COMMENTS FROM INVITED PARTIES RESPONSE – HUNUA QUARRY DEVELOPMENT

Further to your recent instructions, we have reviewed the comments received from invited parties as set out in section 53(2) of the Fast-track Approvals Act 2026 and have responded to the transport matters raised.

Figure 4: Auckland Transport Freight Routes

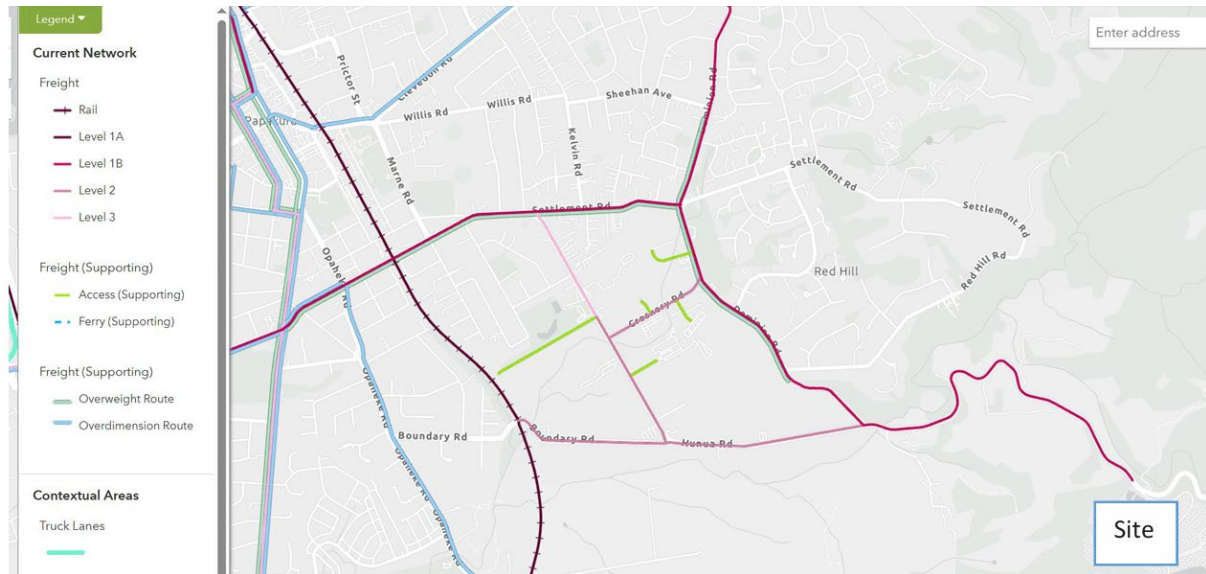
The commenter notes the considerable increase in truck movements and has significant concerns about Hunua Road, which is narrow and windy with sight line issues between Papakura and the entrance to the quarry. Commenter notes that the community reports trucks regularly cross the centre line and are a safety risk to other road users and asks for road widening and realignment to be considered.

It is noted that although the proposal is anticipated to increase truck volumes by 111%, this is at full capacity and this will not occur straight away but instead there will be a gradual increase in truck volumes.

Hunua Road, (to the west of the site entrance) is part of the Auckland Strategic Freight Network. The classification for Hunua Road is 1B which is defined as follows:

This is shown in Figure 4 below.

It is expected that maintenance and upgrades are undertaken by Auckland Transport to ensure that the existing freight and arterial network is adequate for its intended use, which includes large trucks and trailers.

Figure 1: Aerial image showing subject site (outlined in yellow) and area of concern raised by Auckland Transport (red).

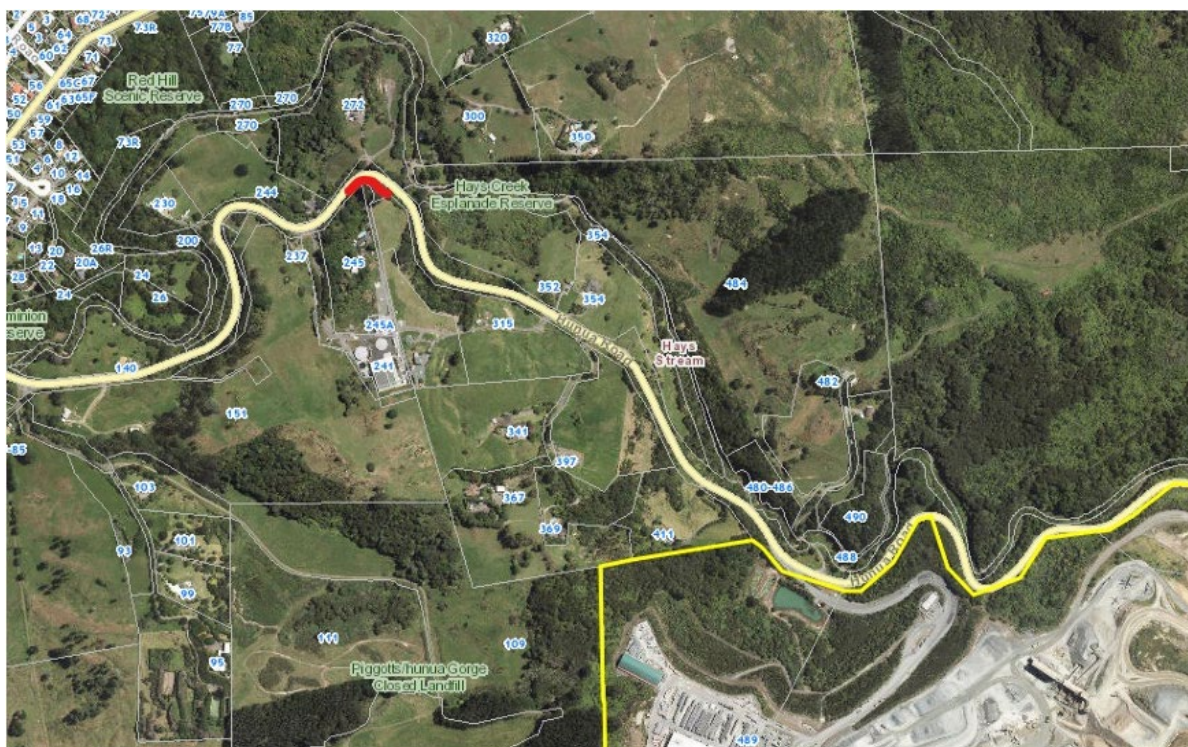
Auckland Transport (Annexure 4) are generally in agreement with the Applicant with respect to effects on the roading network. However, they have an outstanding concern with respect to roading safety at the corner on Hunua Road identified in red in Figure 1 below:

Noted – Refer to Section 2.1.
